Application No. FDEC-R3-175

December 21, 2021

Application for approval to amend the Implementation Plan for Fukushima  
Daiichi Nuclear Power Station as Specified Nuclear Facility

The following amendments are made to the installation of the dilution/discharge system and related facilities for the ALPS treated water and the ocean discharge of the ALPS treated water.

Fig. 2 Plans for monitoring seawater inside and outside port and groundwater (sampling points)

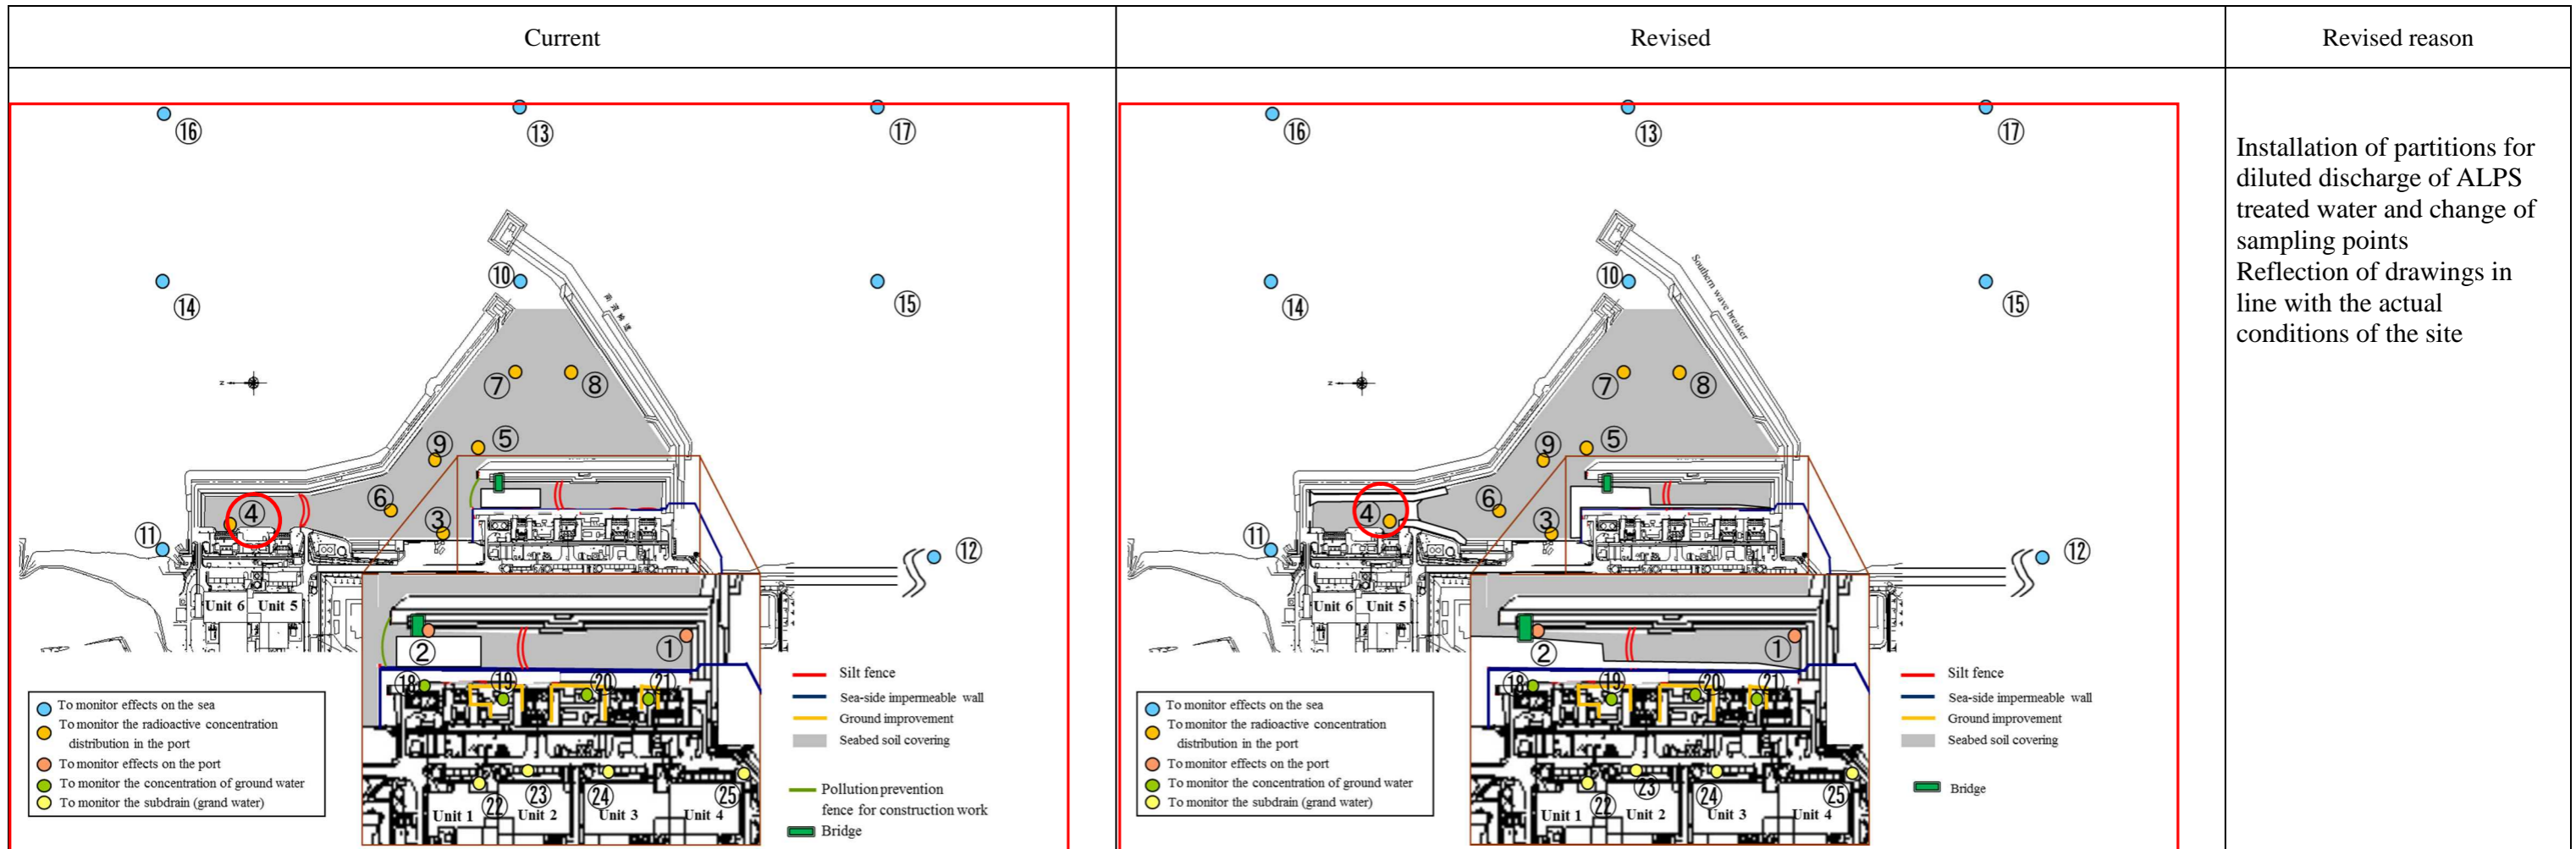
Installation of partitions for diluted discharge of ALPS treated water and change of sampling points  
Reflection of drawings in line with the actual conditions of the site
